**Public Hearing for Rotella's Italian Bakery
Planned Unit Development (PUD)**

RECOMMENDATION REPORT

CASE NUMBER: PPUD-17-0008

RE: Rotella's Italian Bakery
Site Development Plan
Proposed Planned Unit Development (PUD) Site Plan - Initial Review

SITE SETBACKS PLAN

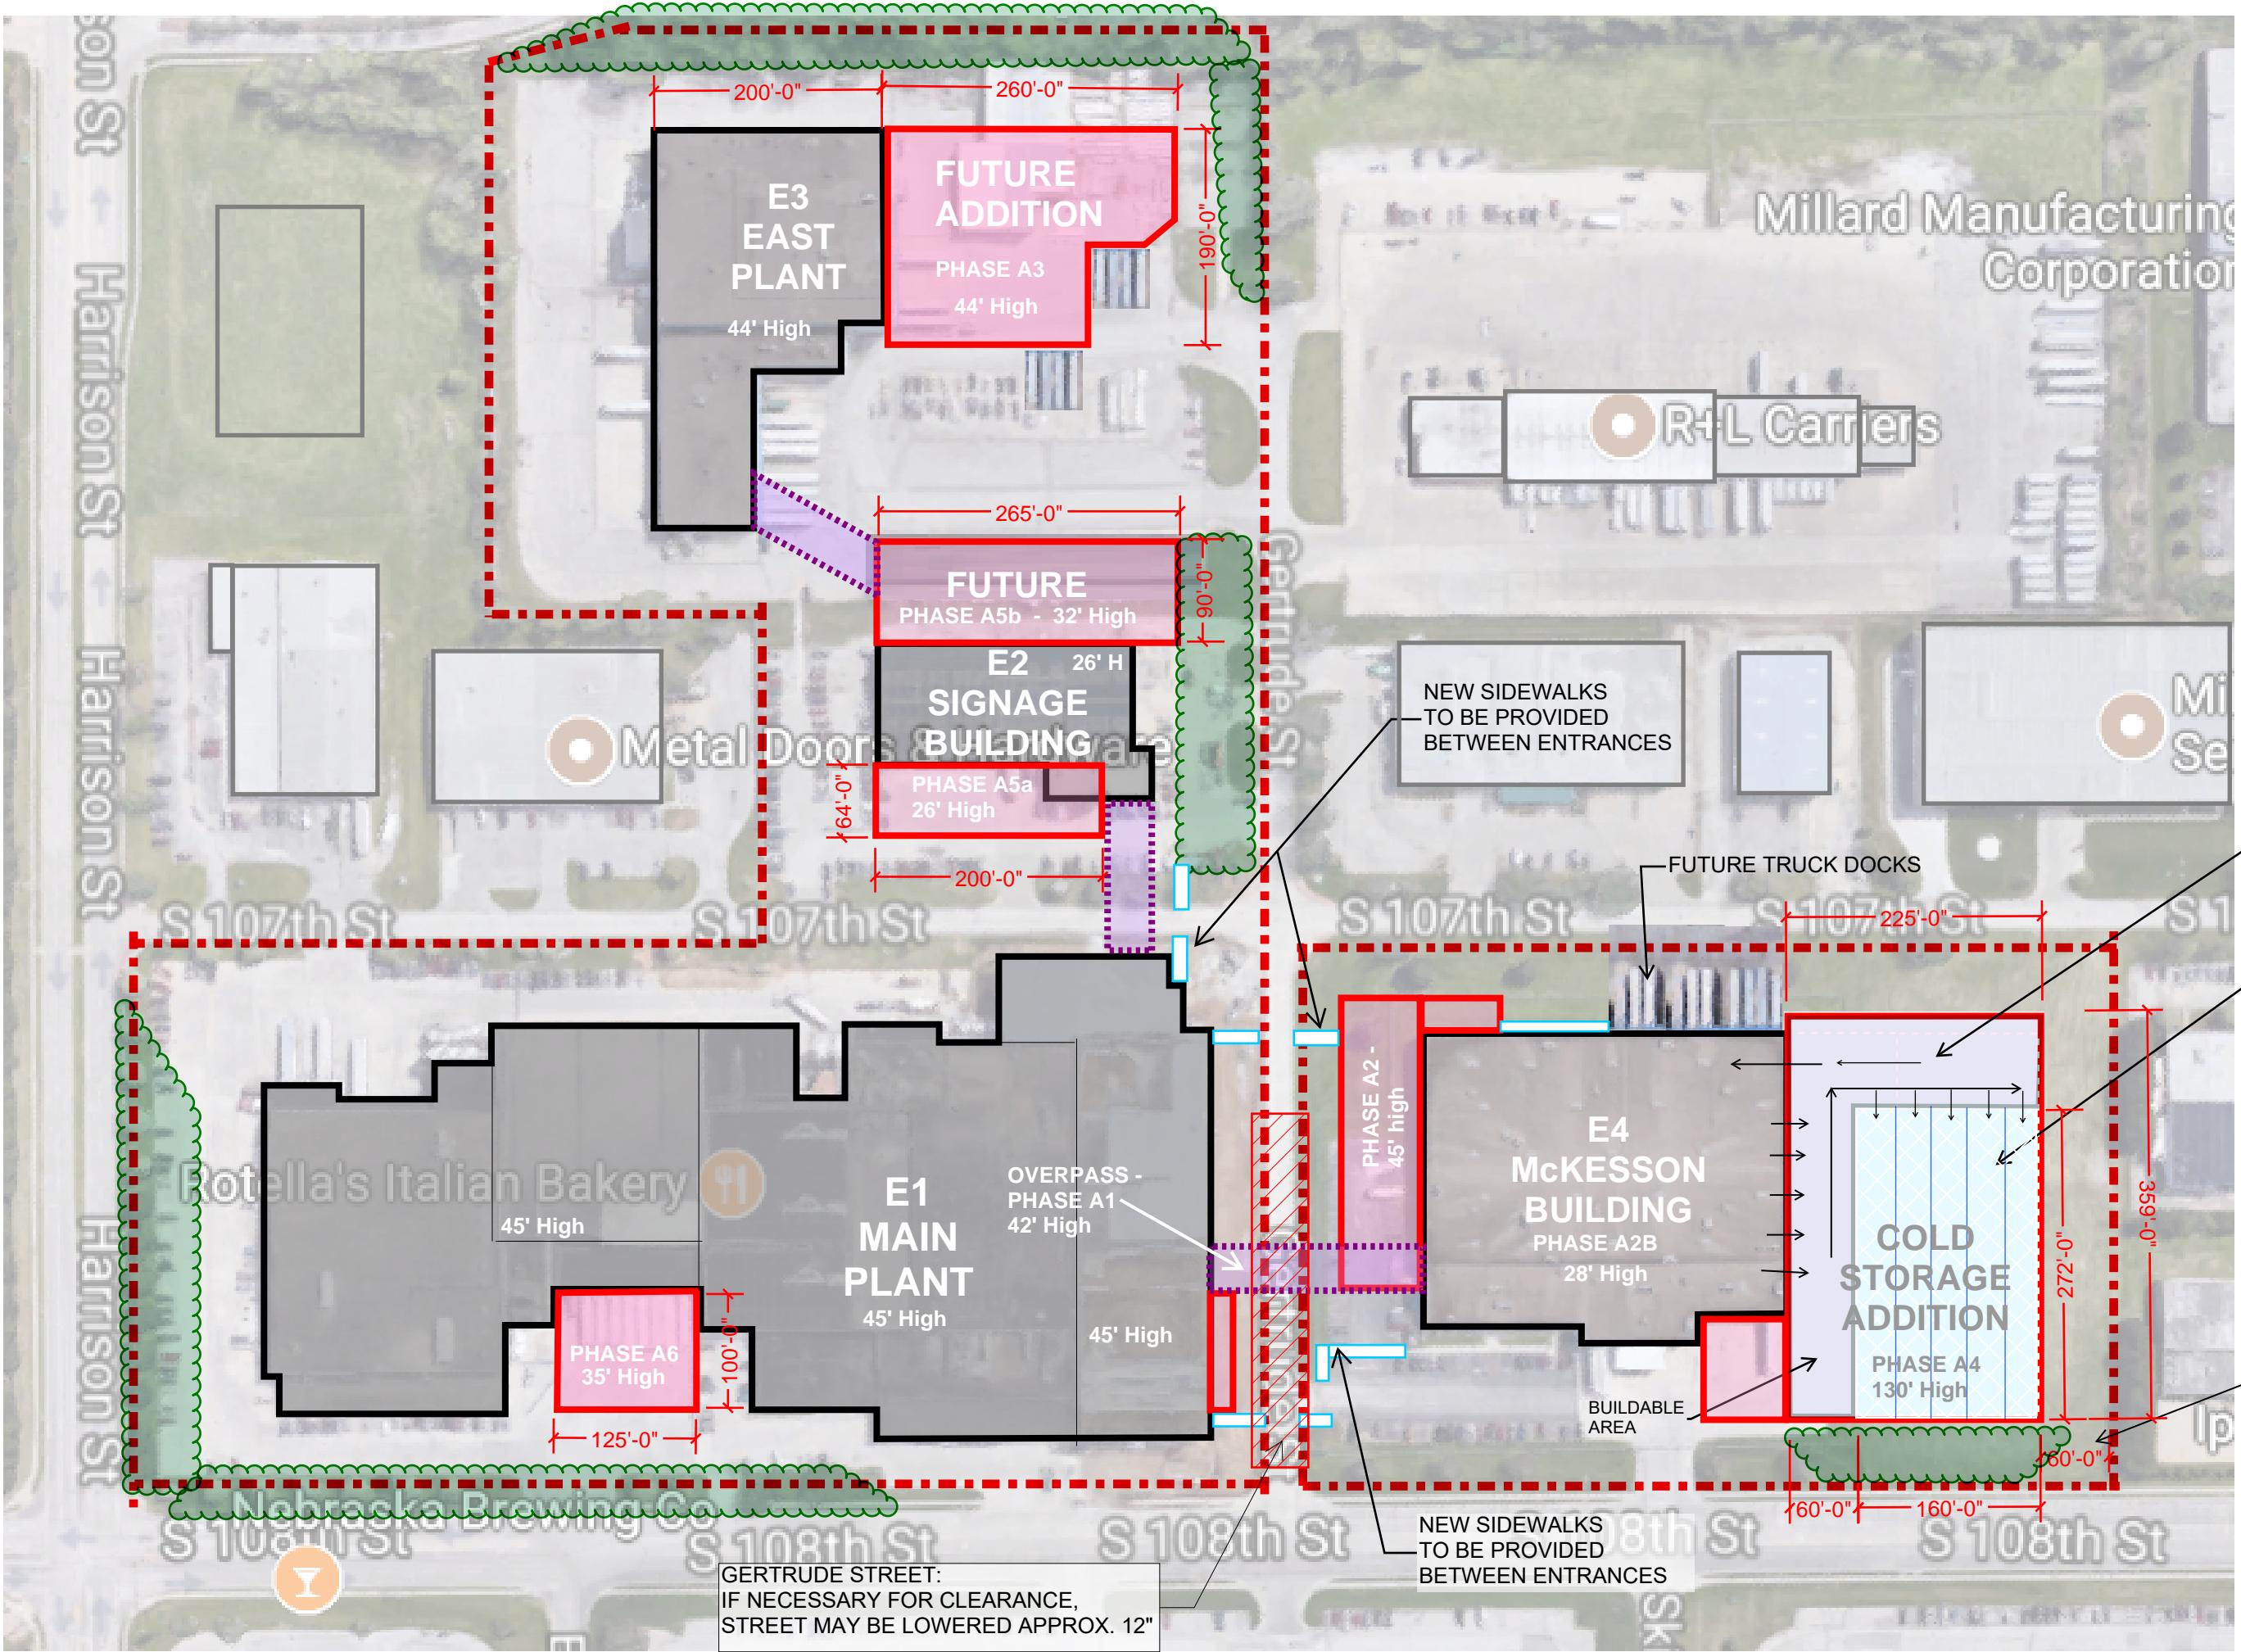
10. Article 5.15.04.09: The Site Plan, Attachment 2, needs to identify the locations and amount of exceptions to setbacks and heights. Additionally, #2 in the Rear setbacks section should be removed as the City does not regulate parking and paving through setbacks. This is completed through the landscaping requirements in Section 7.17. Specifically regarding Table 4, the PUD cannot attribute setbacks based on ownership. Setbacks should be depicted through the PUD site plan. The proposed maximum height allowed of 130-feet is currently under further review.

- i) Comment: Request that setbacks and heights be depicted via the Site Plan (currently listed in Table 4).
- ii) Response: Indication of zoning setbacks have been added graphically to the site plan. **See attached Site Setback plan.**

NEED TO MAINTAIN 60' PERIMETER TO QUALIFY FOR UNLIMITED AREA AS ALLOWED IN THE BUILDING CODE.

60' CAN INCLUDE THE PUBLIC
R.O.W. 35' SETBACK WHEN NO
PARKING IS IN THE SETBACK.
